SERVICE BULLETIN

NACELLE - POWER PLANT - INLET COWL, ACCESS PANEL NUTPLATES - REWORK OF - CATEGORY CODE
6 - MOD.NAC-71-0126

V2500-NAC-71-0126

Addition of Packer Plates to P2T2 Access Panel Attach Land
Fig.1

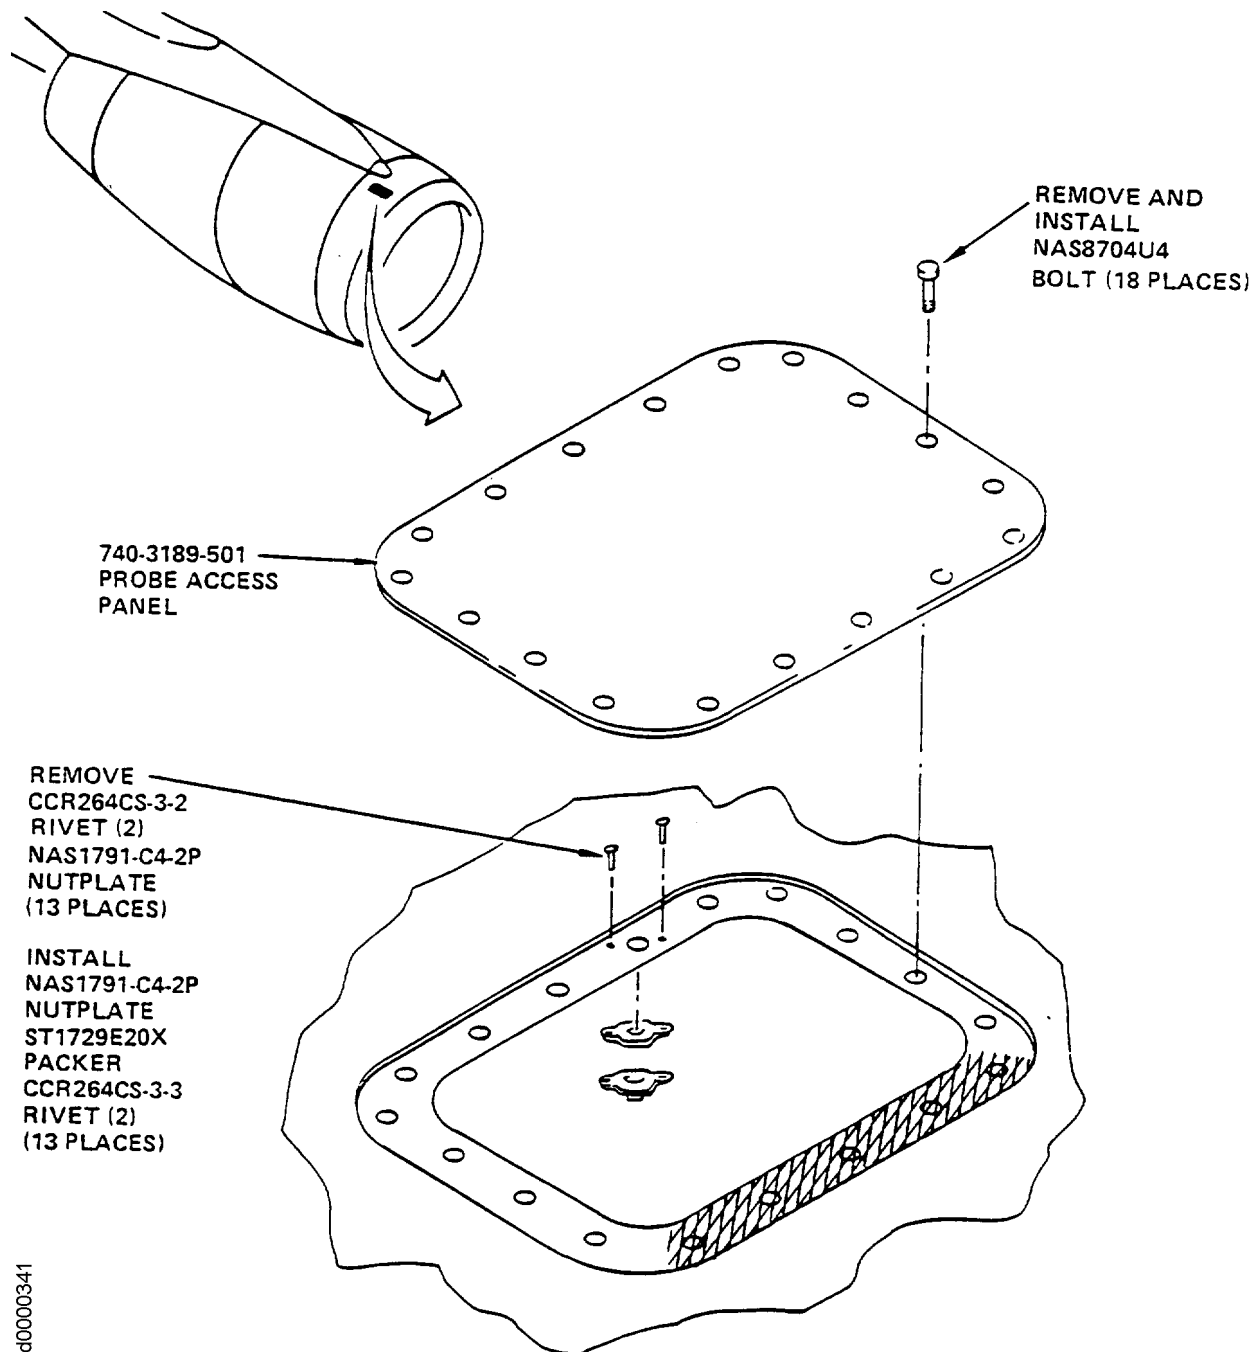
Some bolts which attach the 740-3189-501 probe access panel on the inlet cowl are bottoming out.

To add packers to nutplates to prevent bottoming out condition.

Thirteen ST1729E20X packers are installed with the nutplates to prevent attach bolts from bottoming out.

- (1) Find the 740-3189-501 probe access panel on the 740-3000-565 inlet cowl. (Refer to Figure 1.)
- (2) Remove NAS8704U4 bolts (18 off) which attach the probe access panel to the inlet cowl. Keep bolts and cover. (Refer to Figure 1.)
- (3) Drill out CCR264CS-3-2 rivets (2 off) which attach the NAS1791-C4-2P nutplates (13 off) to the access panel. Remove only those nutplates shown in Figure 1. Keep nutplates.

- (5) Mix 463-6-27 primer, X337 converter, and TL52 thinner with suppliers's instructions.
- (6) Wet install ST1729E20X packers, NAS1791-C4-2P nutplates, and CCR264CS-3-3 rivets in 13 locations. (Refer to Figure 1.)
- (7) Wet install 18 bolts which attach the probe access panel to the inlet cowl.
- (8) Reidentify the 740-3000-565 inlet cowl as 740-3000-573.
